FUEL SYSTEM

No. C-11

MODEL: LIGHT CAR RANGE (1725 cc CAST IRON  
HEAD ENGINE)

SUBJECT: CARBURETOR ICING

8404

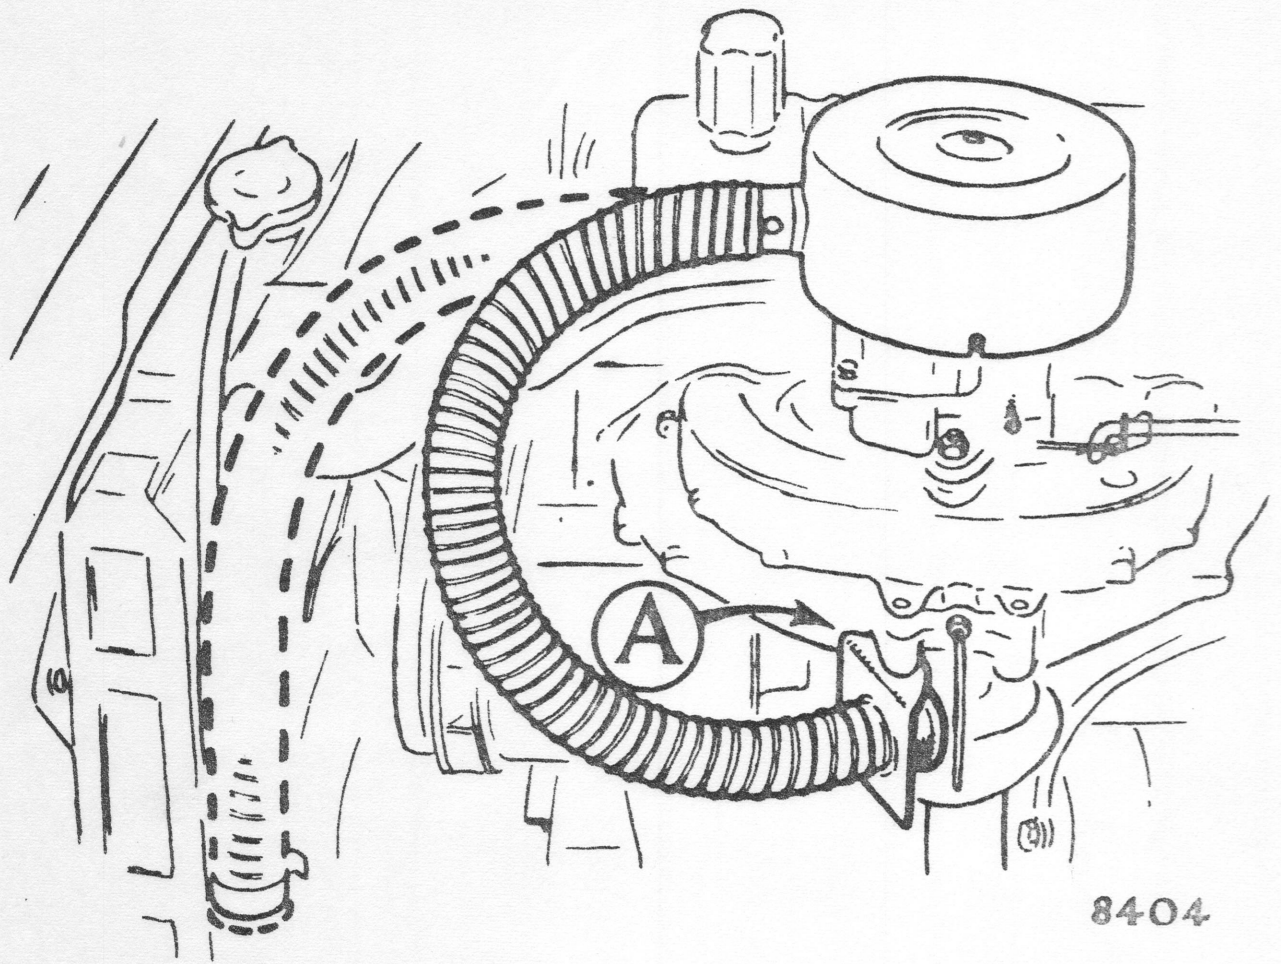
A carburetor de-icing bracket, Part No. 1238410, should be fitted to the front outer bolt of the manifold hot spot as follows:-

- 1) Remove front outer hot spot bolt together with plain washer.
- 2) Open mounting flange of de-icing bracket in order that the displaced bolt and washer can be fitted through the bracket.
- 3) After fitting bolt through bracket, re-align flange to original position.
- 4) Refit bolt together with bracket to front outer position of hot spot and tighten bolt, so positioning the bracket that its inner edge butts against the exhaust manifold as shown 'A' in illustration.
- 5) Remove air cleaner intake hose from clip on side of radiator, at the same time withdrawing the metal intake flange. (This flange should be retained in the car for Summer use).
- 6) Position open end of intake hose on de-icing bracket.

For summer use and/or continuous high speed motoring, the intake hose should be returned to its original position adjacent to the radiator.
